June 10, 2019

**Re: PADEP HDD Re-Evaluation Report- Request for additional information
Appalachian Drive 16" Horizontal Directional Drill Location (S2-0240-16)
Permit No. E21-449
Middlesex Township, Dauphin County**

FIGURE 2
GEOPHYSICAL SURVEY DATA COVERAGE MAP
AND HISTORICAL KARST FEATURES

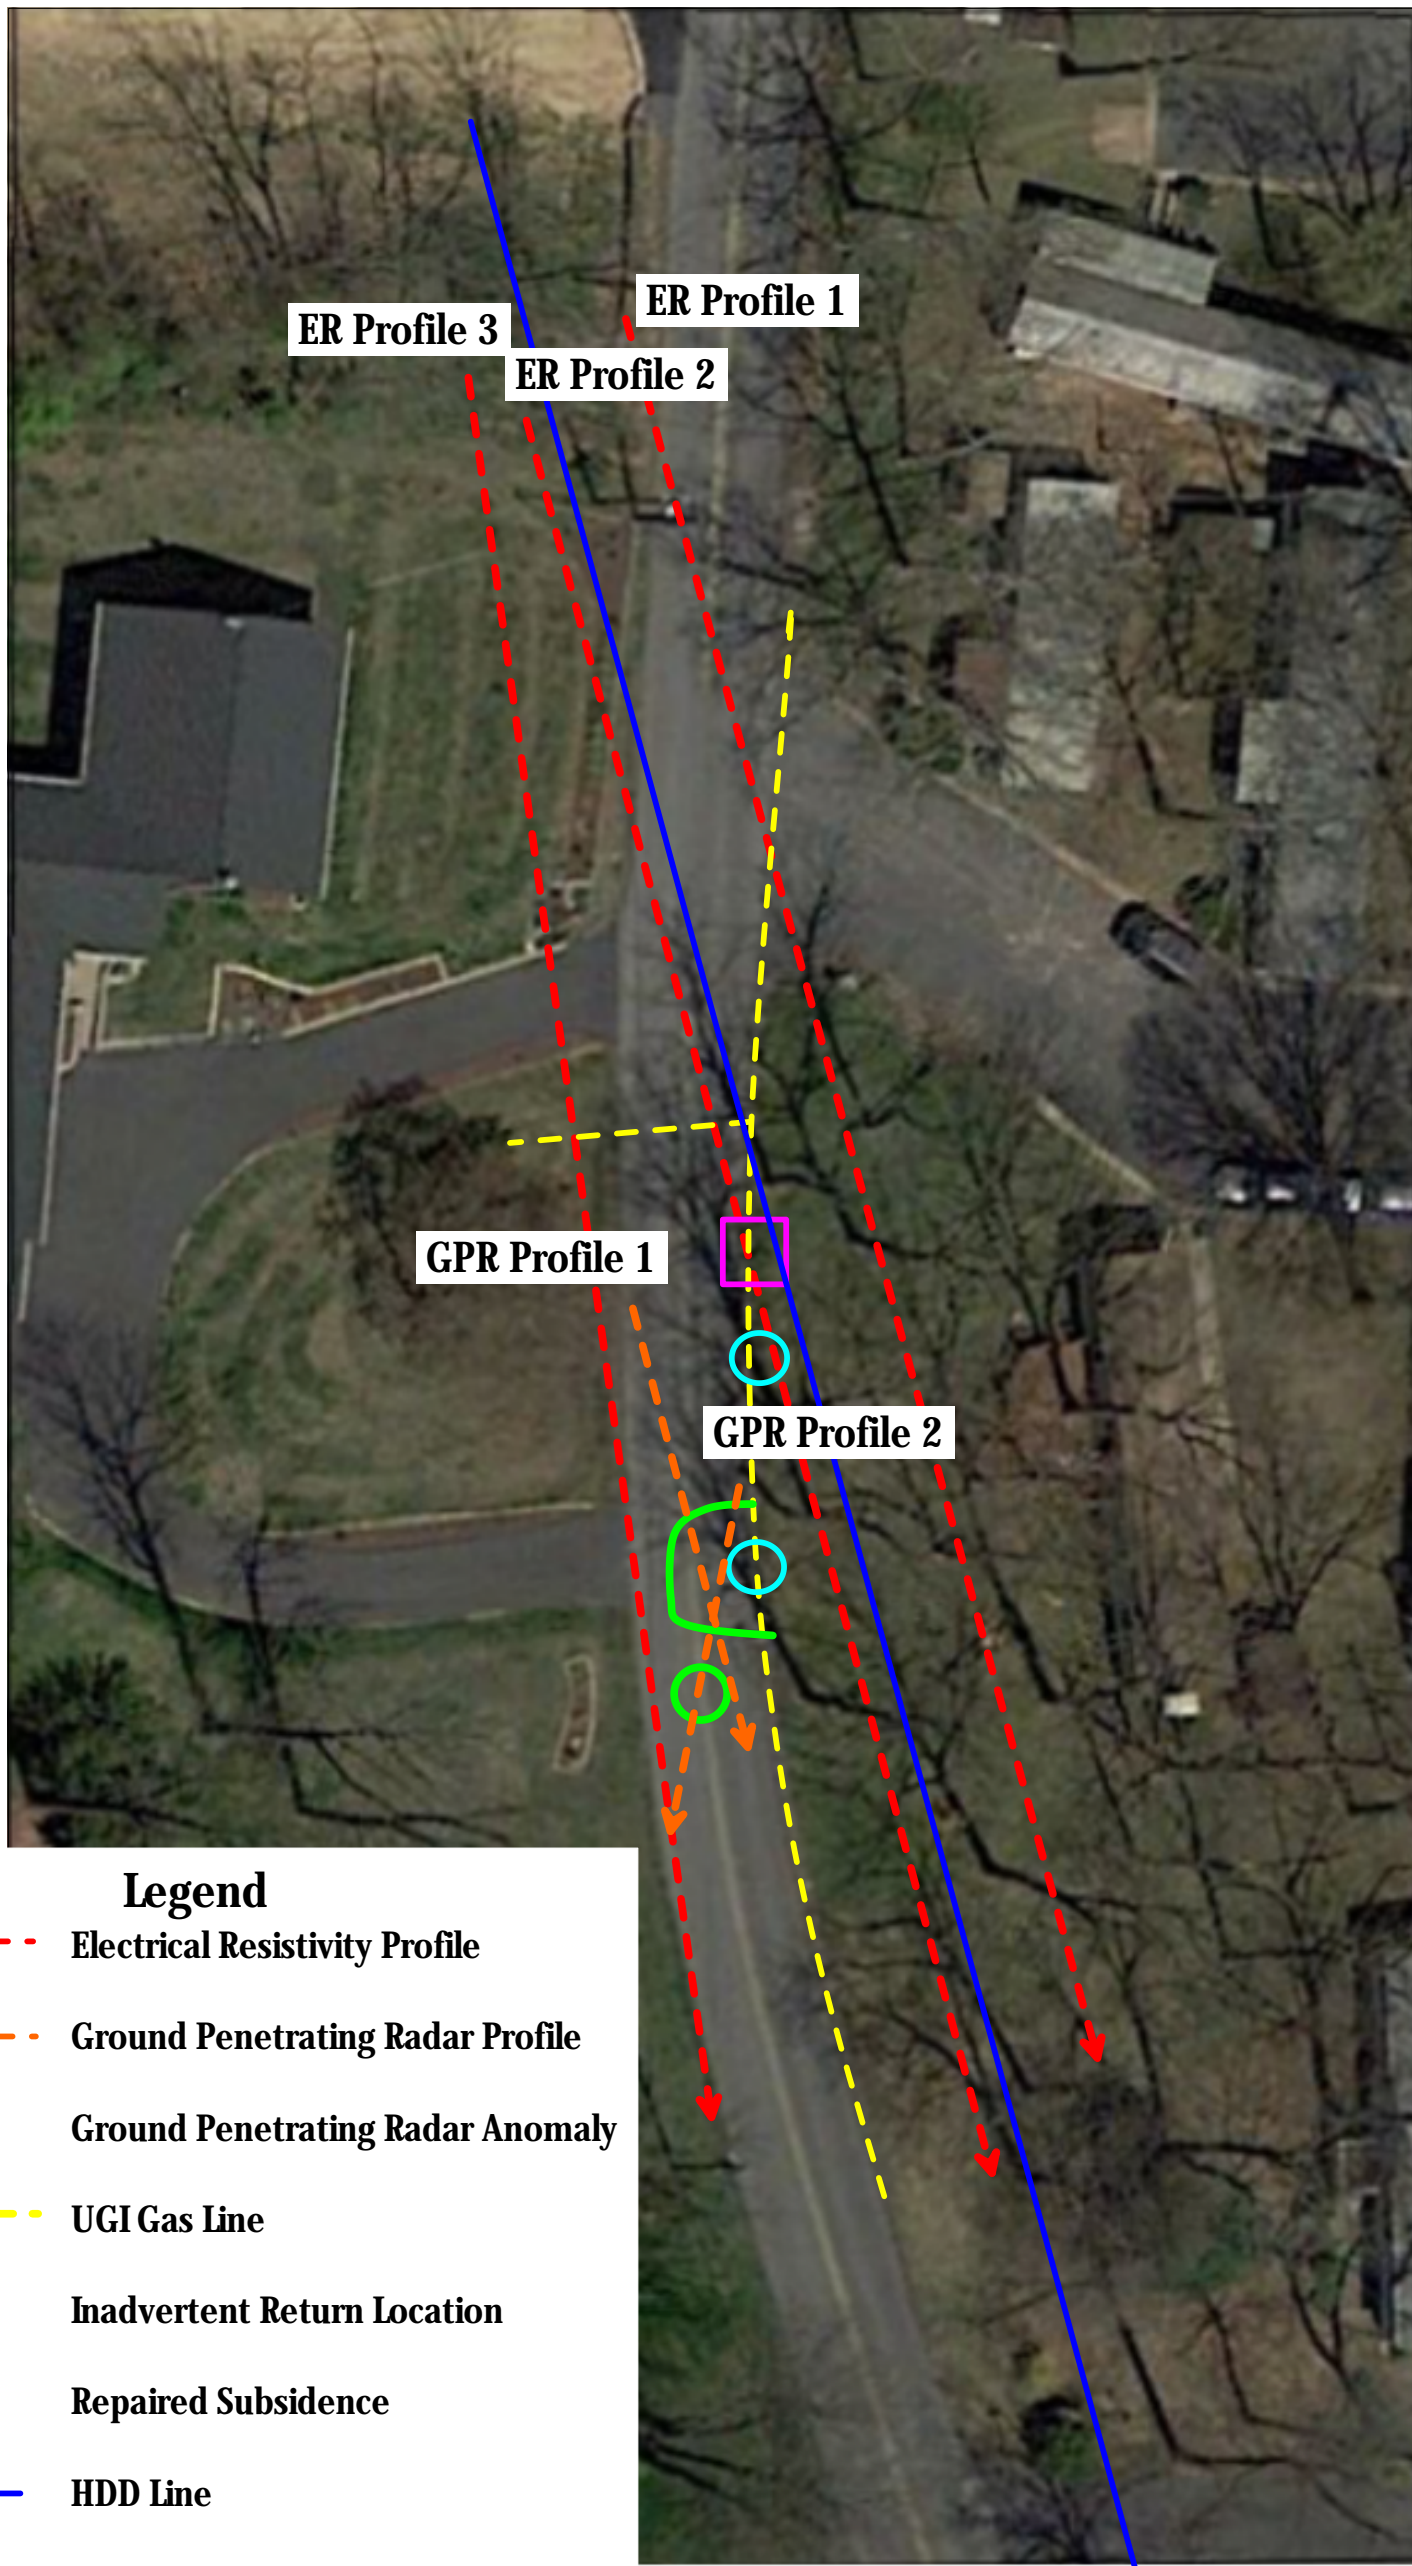
a. During the installation of the 20-inch HDD, a geophysical survey with electrical resistivity, microgravity and ground penetrating radar (GPR) was completed for specific areas. However, these areas of geo-physical investigations were not shown on any plans or mapping or discussed within the re-evaluation report. Where were these areas? Was a geophysical survey completed on the area where the "guided bore" is being proposed? If not, we strongly recommend that a geophysical survey be completed for the "guided bore" (HDD pilot) portion of the 16-inch pipeline redesign or a provide adequate justification for why geophysical surveys will not be done at this portion of the Appalachian Drive site.

The geophysical survey was completed in the area of the subsidence features observed along Appalachian Drive at the north end of the 20-inch HDD. The survey was conducted to detect and delineate the subsurface voids or areas of low density bedrock beneath Appalachian Drive. A geophysical survey was not completed in the area of the proposed guided bore. Based on the results of the 2017 geotechnical investigation (which did not encounter any voids until a depth deeper than the guided bore designed profile depth and the presence of high RQD values) a geophysical survey along the guided bore would not produce any additional information that can be utilized to reduce the potential for a loss of circulation, IRs, sinkholes, or impacts to residential water wells.

Well Location Map
HDD# PA-CU-0136.0020-RR
Cumberland County, PA.

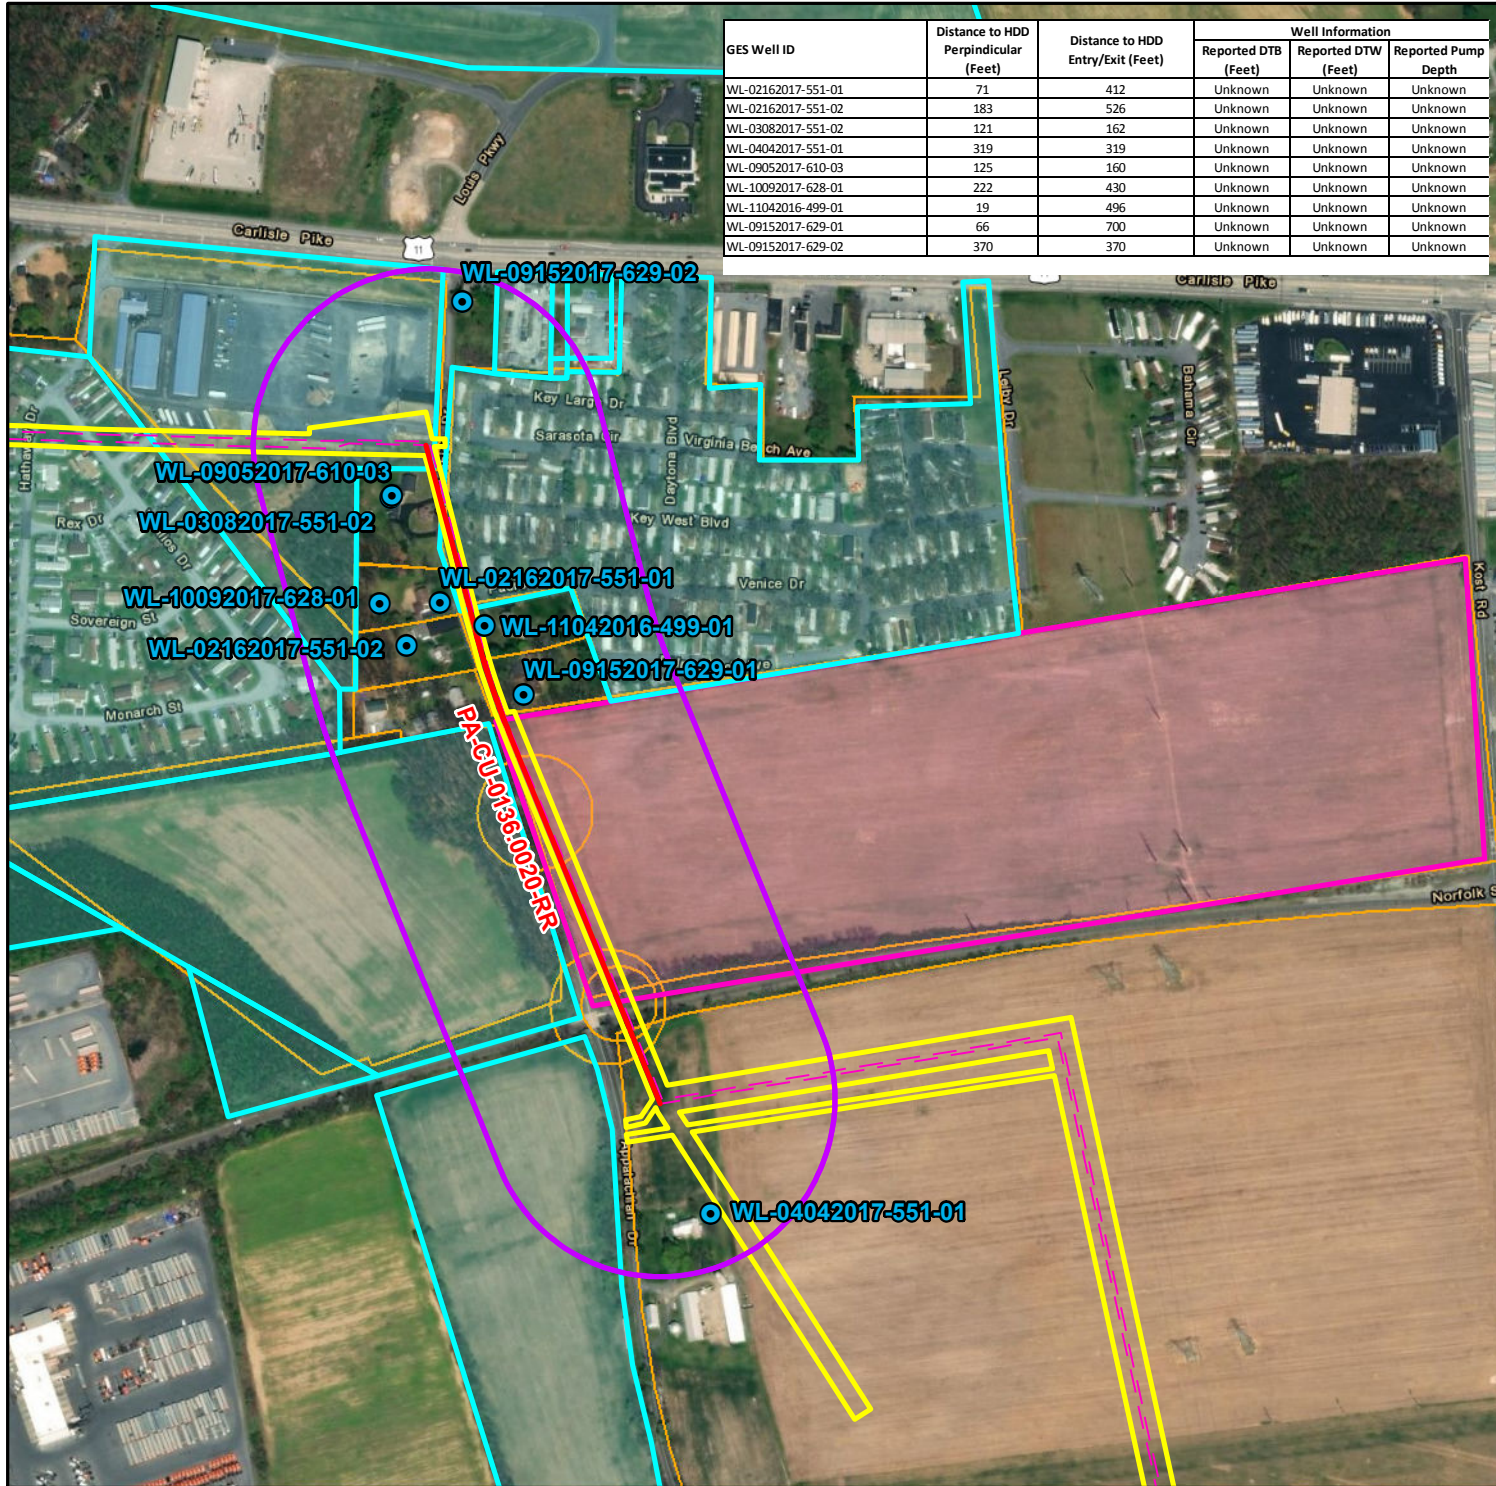
In addition, Figure 3 of the Geology Report shows two wells in the vicinity of the 16-inch "guided bore" (PA Well ID 97976 and PA Well ID 98290). Attachment 3 of the Geology Report does not list or show these two wells. Please locate these two subject wells on Attachment 3 Supplemental Water Supply Information.

Any private or public water supply data obtained within 450 feet or otherwise obtained in the vicinity of the 20-inch or proposed 16-inch HDD should be used and discussed as part of this HDD reevaluation. This data should include but not be limited to any applicable water supply sampling data and any water supply complaints that SPLP may have obtained and received for water supplies within 450 feet of the HDD or within the general vicinity during construction of the 20-inch pipeline. The results of the SPLP's water supply sampling program, investigation, disposition of the complaint, and any correlation or non-correlation to SPLP's construction activities should be evaluated and discussed in the HDD re-evaluation report. Use the report to demonstrate how the proposed 16-inch HDD activity will minimize the potential for IR's and impacts to water supplies. Please revise the reevaluation report to include this information.

As part of the re-evaluation process and in accordance with the Corrected Stipulated Order, dated August 10, 2017, SPLP conducted a survey of water supplies located within 450 feet of the proposed guided bore. Additional surveys were also conducted for the portion of the originally permitted 16-inch HDD, which is now going to be completed by open cut installation techniques. The responses that SPLP received are represented graphically on the figure contained in Attachment 3 of the Hydrogeologic Report. As of March 1, 2019, SPLP has received a total of nine (9) responses to their survey requests with no information pertaining to the depth of the well, amount of surface casing or specific yield being provided. In addition to the survey, a search of the Pennsylvania Groundwater Information System (PaGWIS) was completed within a 0.5-mile radius of the Appalachian Drive location. A total of 24 water supply wells were identified within PaGWIS, with 17 of the wells being identified for domestic usage. None of the wells identified within the PaGWIS database search were identified within the 450-foot survey completed by SPLP. However, two wells were identified in the PaGWIS search that were not identified in the 450-foot survey and these wells have been added to the revised 450-foot well location map attached to this response.
